**FINAL DRAINAGE REPORT  
FOR  
SOLACE APARTMENTS**

**November 25, 2020  
Project No. 25174.00**

PCD File No. PPR-20-047

EXISTING DRAINAGE MAP  
 SOLACE APARTMENTS  
 JOB NO. 25174.00  
 8/26/20  
 SHEET 1 OF 1

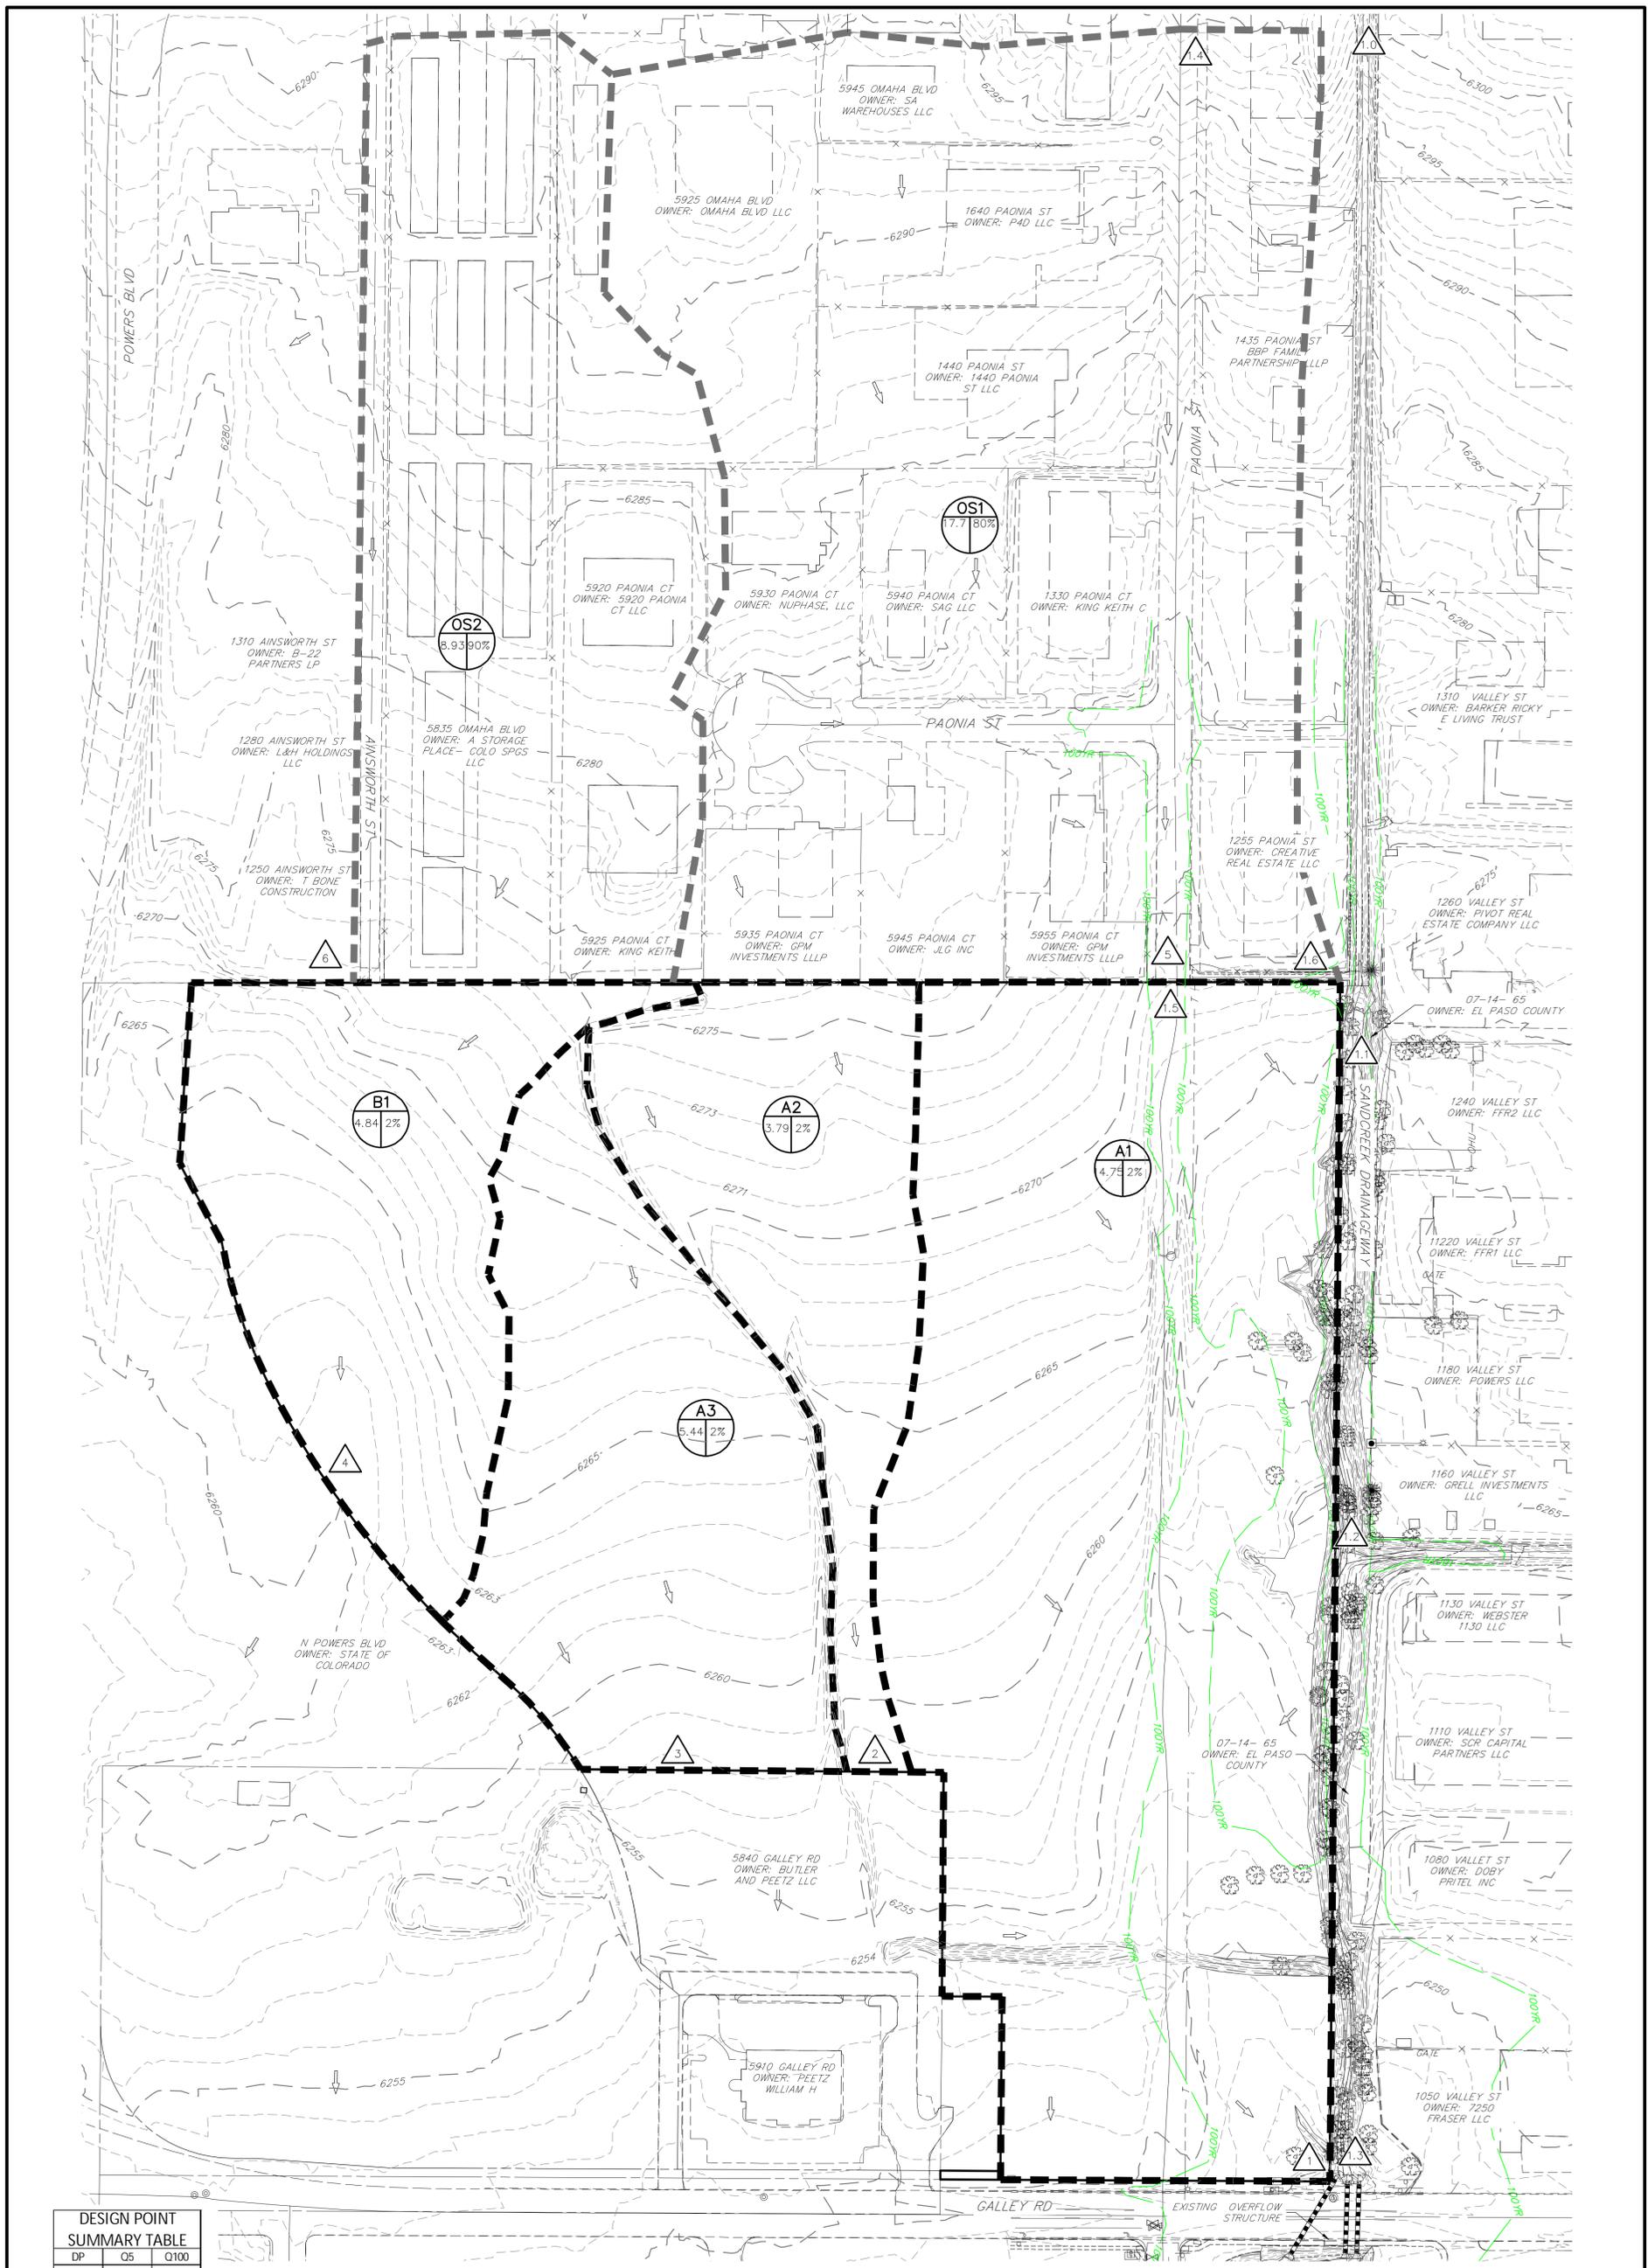
Please provide a basin for this area. Account for it in your analysis/design and address in the narrative.

DRAINAGE MAP  
SOLACE APARTMENTS  
JOB NO. 25174.00  
11/25/20  
SHEET 1 OF 3

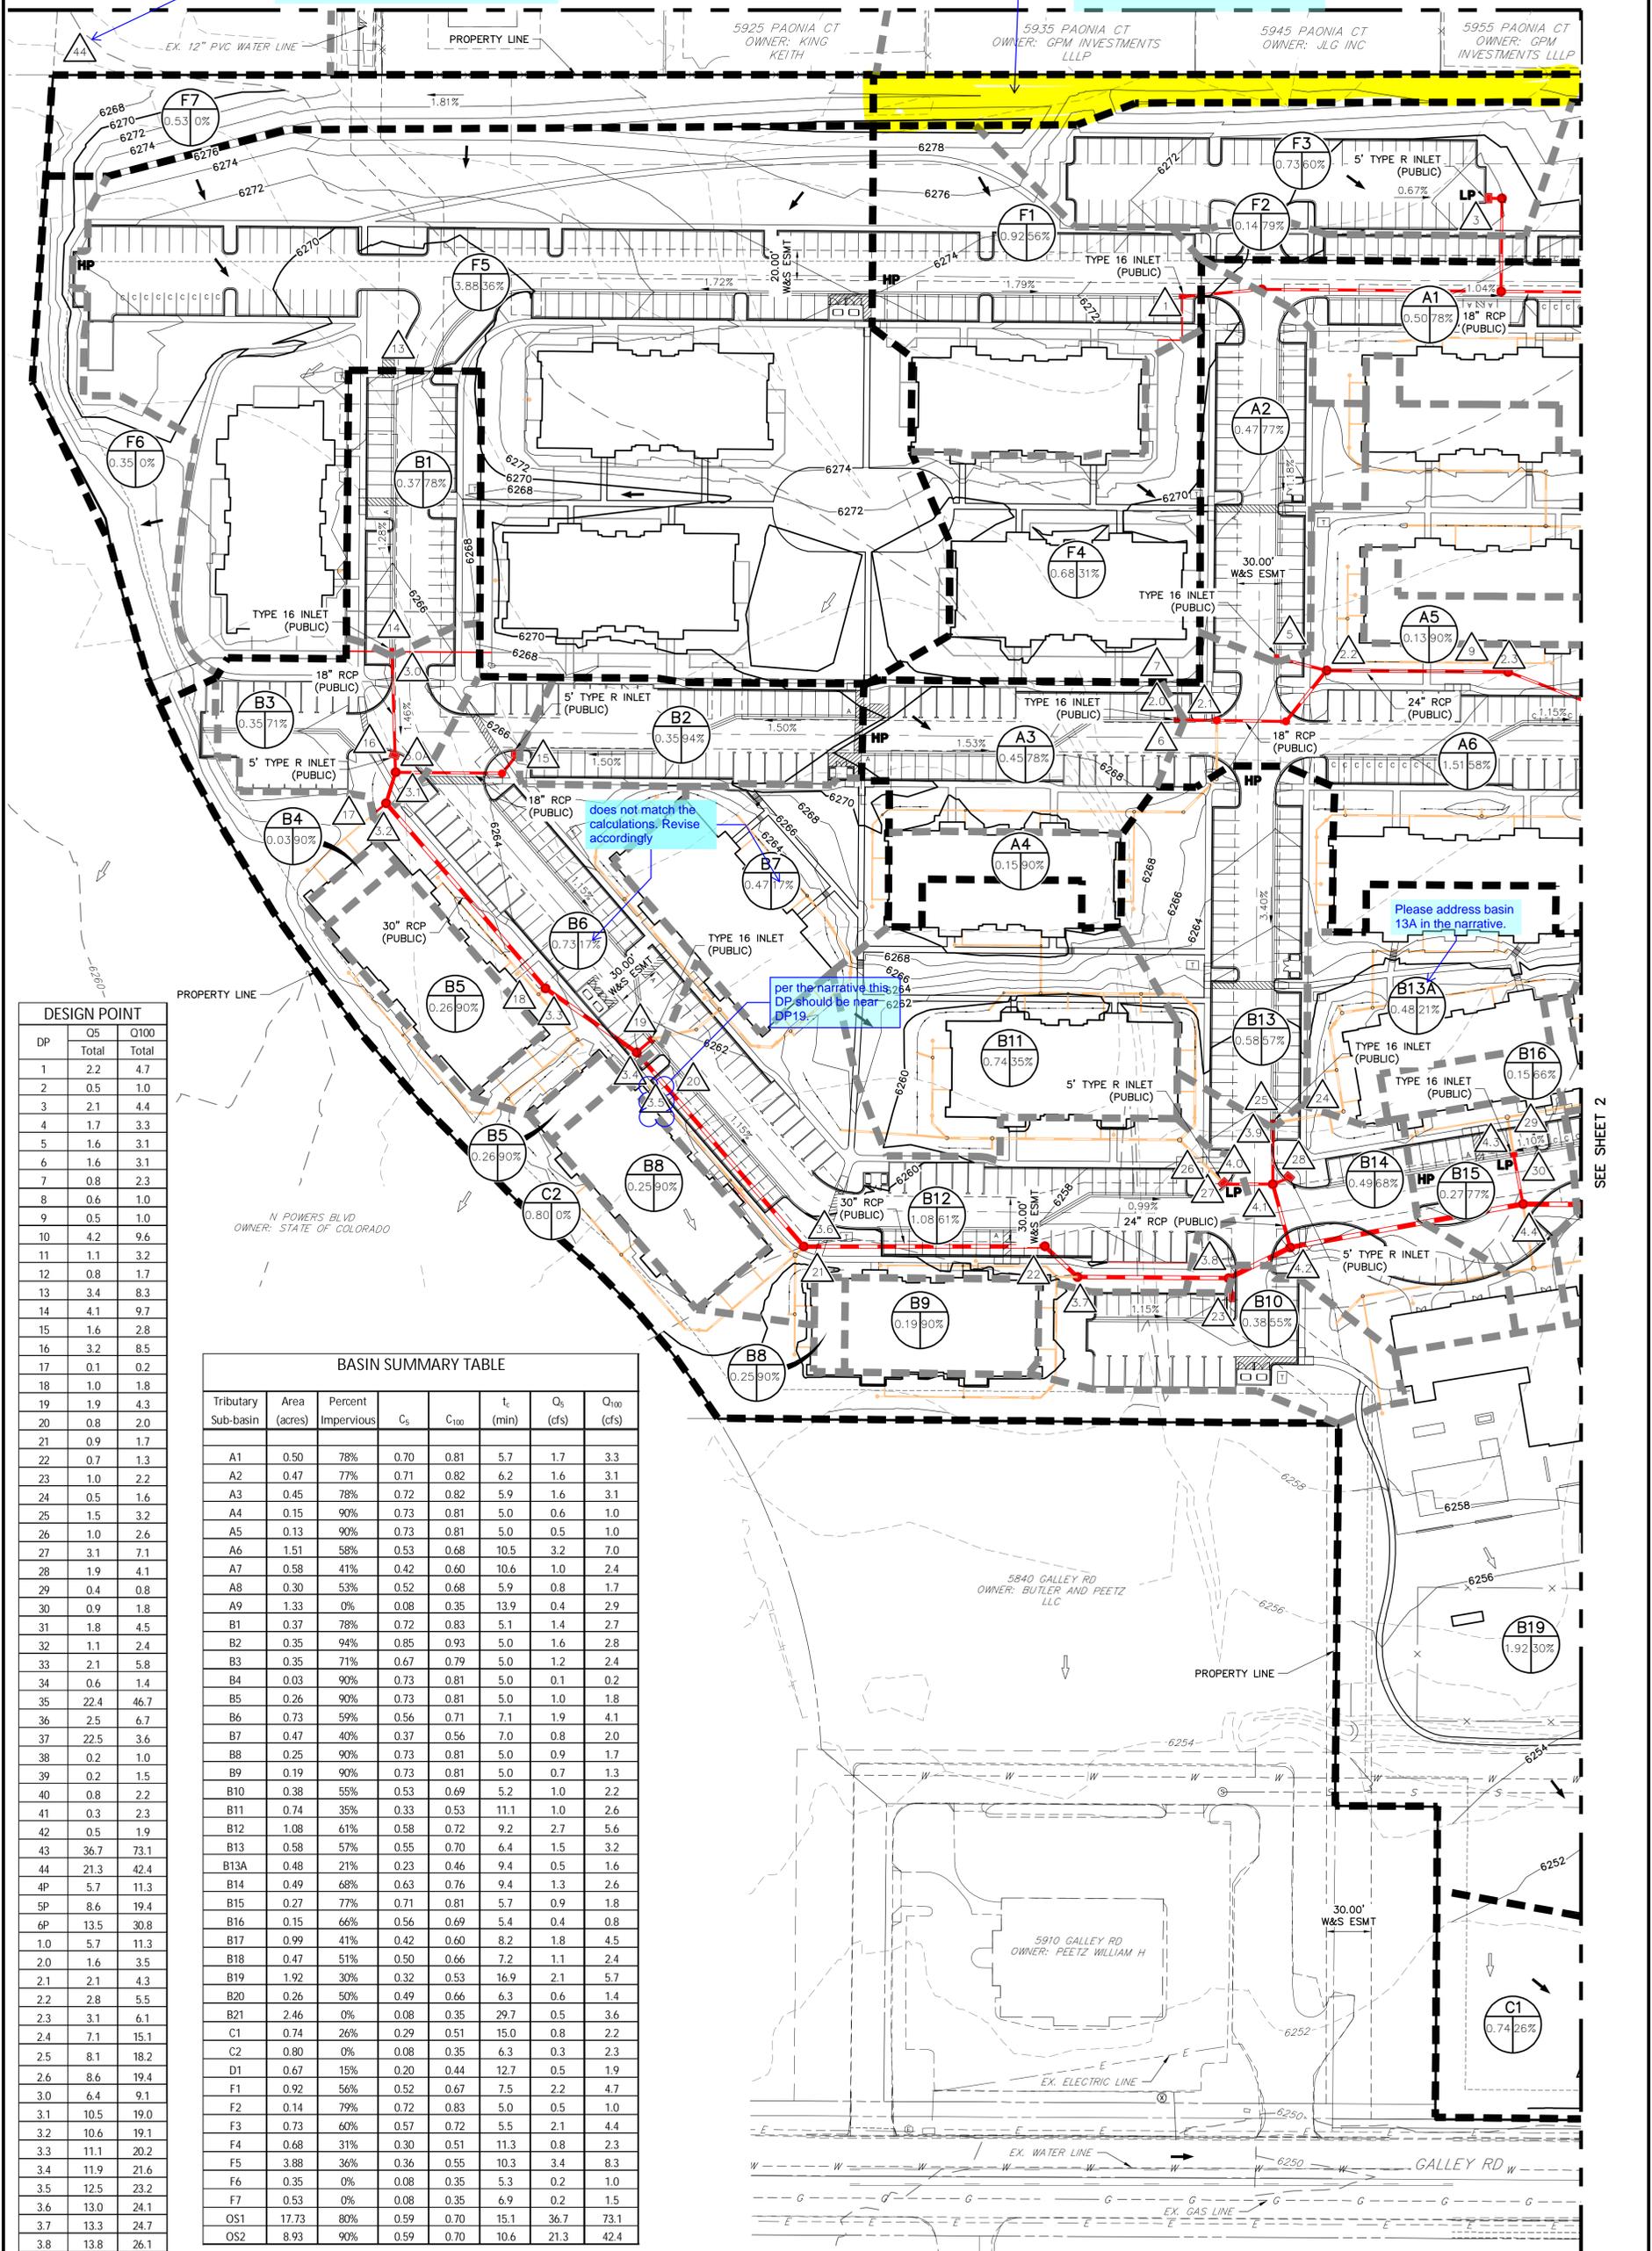
Please add this gray linetype to the legend.
